LRB-2021-36
21/00550/FLL – Formation of two landscape bunds and associated access track, Binn Eco Park Wind Farm, Glenfarg

**PAPERS SUBMITTED
BY THE
APPLICANT**

This Notice of Review is submitted following the refusal of planning permission 21/00550/FLL under delegated powers on the 14 July 2021 for the formation of 2 landscape bunds and access track at Binn Eco Park. (Doc 1)

Initial representation provided by the developer of bunding to screen the wind turbines based on a topographical survey and computer modelling

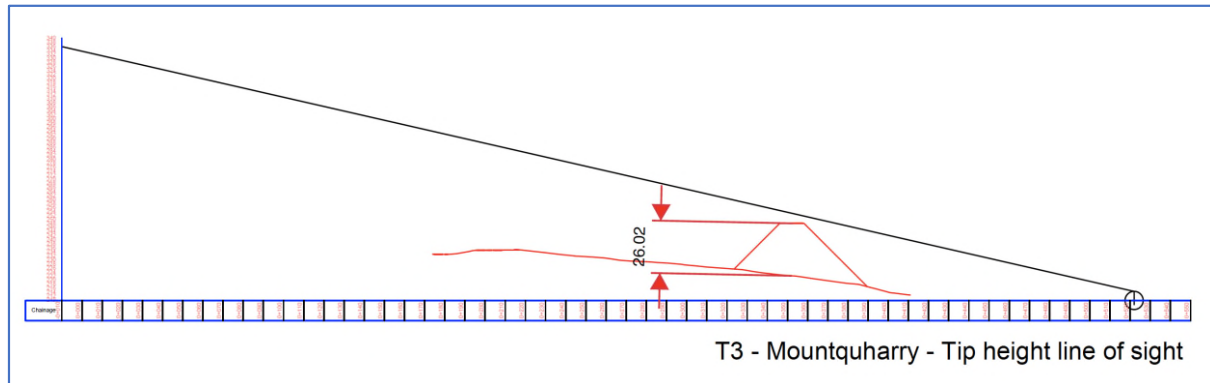
We are the occupiers of that neighbouring property. Indeed, as the most proximate property to those wind turbines, it is our home whose visual amenity has been most adversely impacted by the constriction of those wind turbines.

However, despite the developer's endeavours in this application to mitigate that adverse visual impact by the formation of two bunds, we want to clearly and unambiguously record our opposition to the proposal to create these bunds by registering our **objection** to this planning application and proposing that it be **refused**.

Bund long cross section included in planning application.

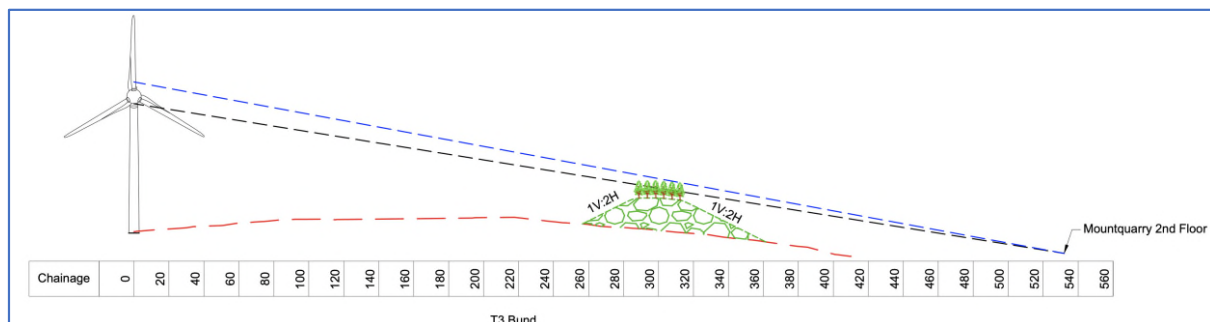
It is interesting to note that the initial supporting planning statement for this application (1 April 2021), indicated bund heights of 26m and 25m but was withdrawn and replaced by a statement indicating bund heights of 18m, consistent with the bund cross sections submitted on the 15th April 2021.

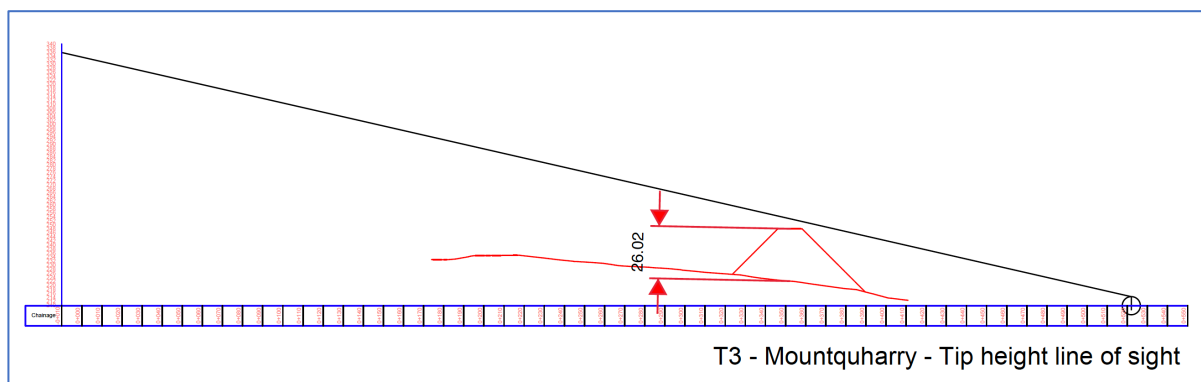
Along with appropriate mature tree planting, such a scheme would have entirely hidden the wind turbines, right to the maximum height of the turbine blades, completely obliterating the mast, the motor and the blades, as viewed from the upstairs windows of our property.

For us, such a scheme brought the added benefit that it would almost certainly address the shadow flicker nuisance that we currently suffer and that the physical barrier might also provide some mitigation against turbine noise.

Bund long cross section included in planning application

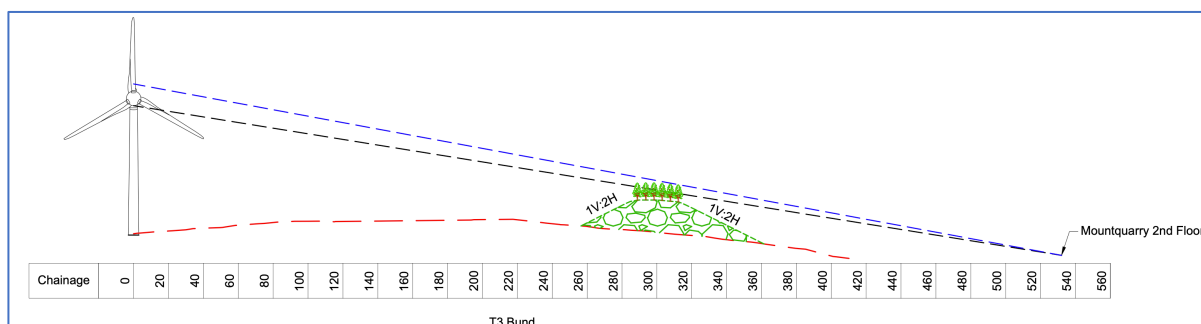
Although the initial supporting planning statement for this application (1 April 2021), indicated bund heights of 26m and 25m that was withdrawn and replaced by a statement indicating bund heights of 18m. The consequences of that, as can clearly be seen from the visual representation accompanying the planning application, is that part of the mast, the entirety of the motor and the full extent of the turbine blade will still be visible and audible from our property.
